IMMINGHAM EASTERN RO-RO TERMINAL

Environmental Statement Addendum

Document 10.3.8

November 2023

Figure 7.1. Peak flood baseline flow speed and predicted change

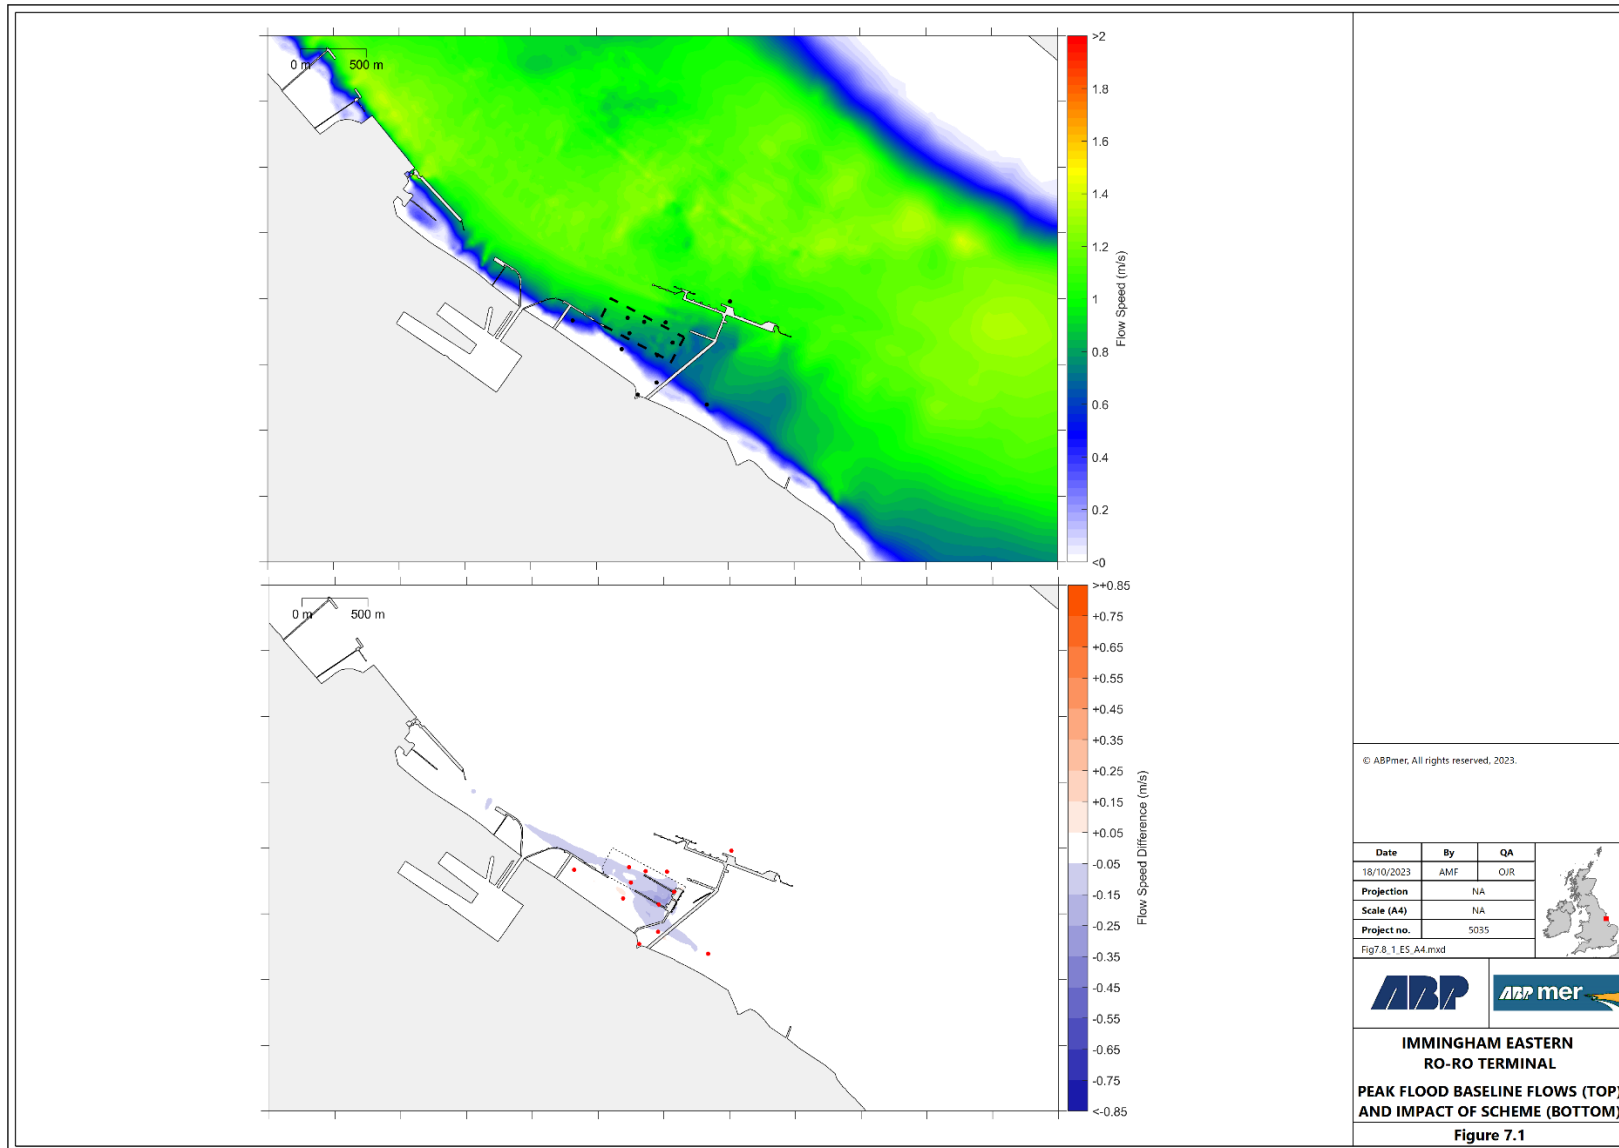
Consultee	Reference, Date	Summary of Response	How Comments have been Addressed or Considered in this Chapter
		<p>increased capital or future maintenance dredge requirement volume.</p>	
		<p>The MMO has noticed that Figure 7.1 (Peak Flood Baseline Flows) appears to show a reduction in flow speed differences relative to the original Figure 7.8 in the ES while Figure 7.2 (Peak Flood Baseline Flows) suggests a much larger impact than the original Figure 7.9. It would be of value if this difference could be explained.</p>	<p>The predicted changes to peak flood and ebb flow speeds are generally very similar in magnitude and extent between the ES and those presented in this chapter as a result of the Proposed Changes. There are slight differences between the two where changes flip into the '-0.05 to -0.15 m/s' band on the colour scale, as a result of the changes to the marine layout (pile locations). Overall, the magnitude and extent of change remains similar and the assessment conclusions are unchanged.</p>

Figure 14.1. Sound monitoring locations

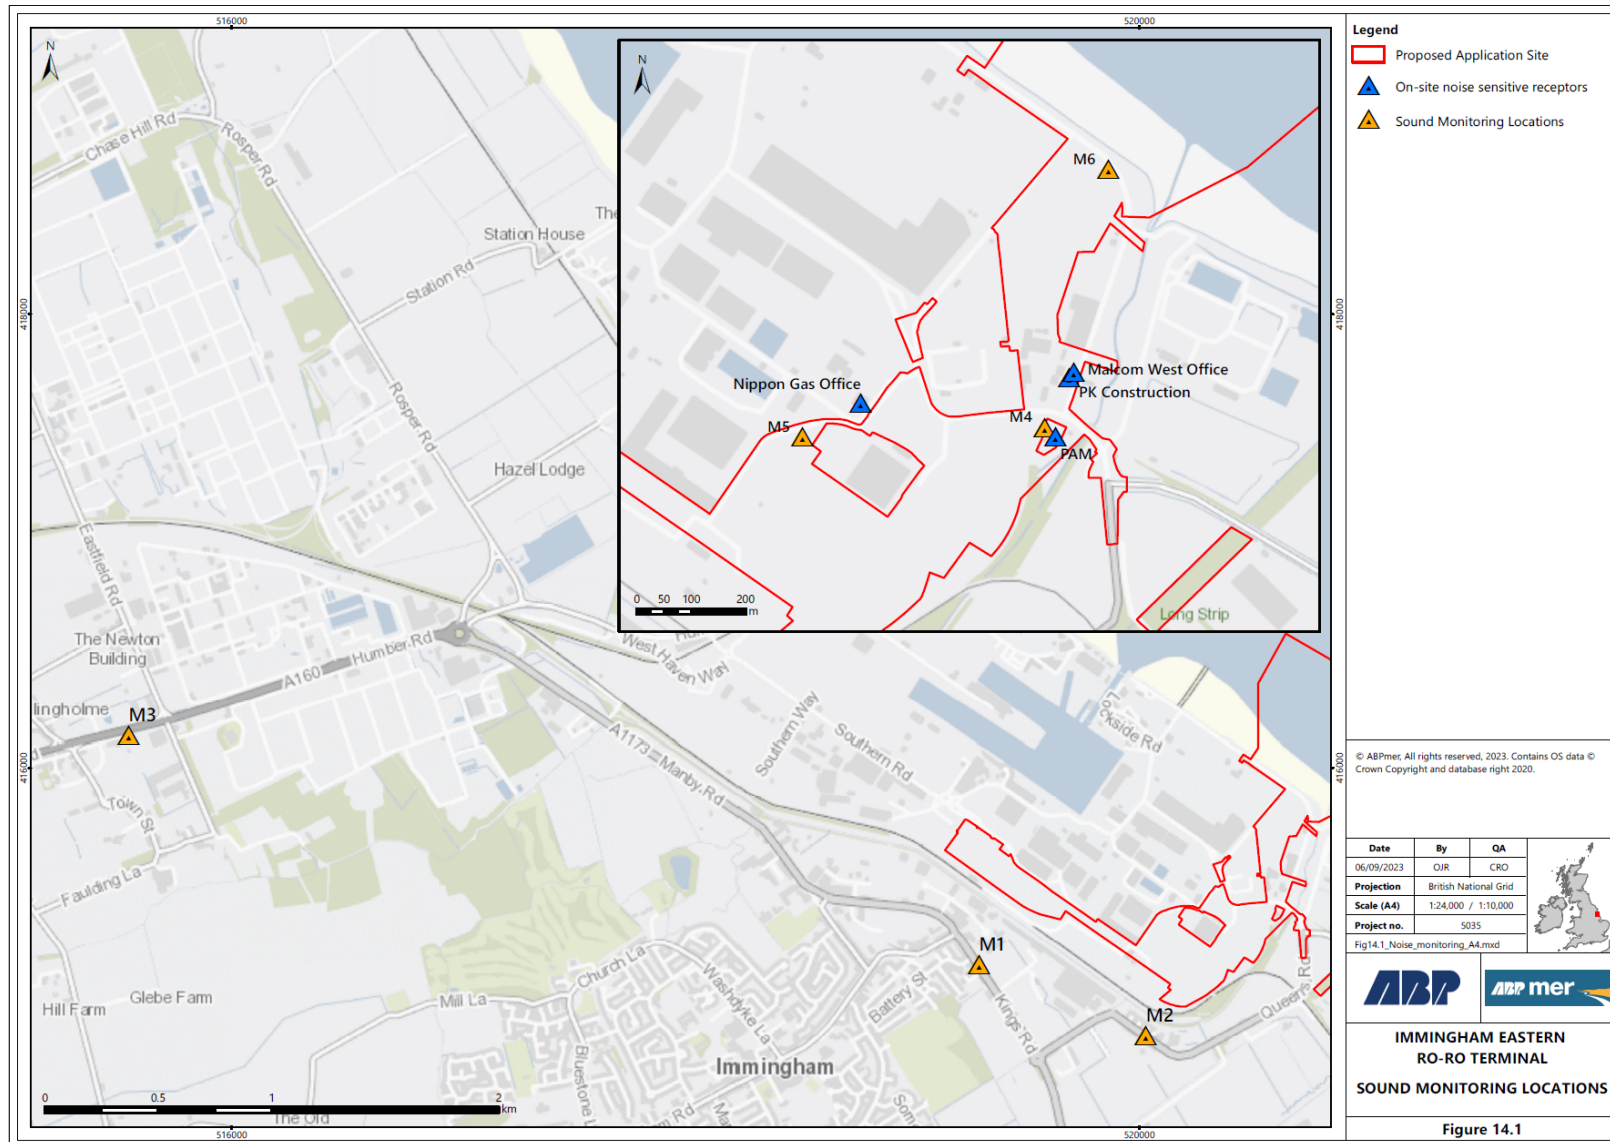
- 14.3.7 The relocated Malcolm West Office building is adjacent to the existing PK Construction Office building, as shown in Figure 14.1 below. The current ambient noise levels at monitoring location M4 (as reported in Chapter 14: Noise and Vibration [APP-050]) is also representative of the relocated located Malcolm West Office building. The Malcolm West Office building has been assigned as being medium sensitivity based upon Table 14.11 in Chapter 14: Noise and Vibration [APP-050]. To avoid a significant adverse effect on occupants of the Malcolm West Office building, a construction noise of 75 dB $L_{Aeq,12\text{ hr}}$ would apply. This is the same limit as for the PK

14.4.1 Figure 14.1 in Volume 2 of the ES relating to Chapter 14: Noise and Vibration [APP-070] of the ES has been updated to include the relocated Malcolm West Office Building. This is provided at the end of this chapter and is referred to as Figure 14.1.
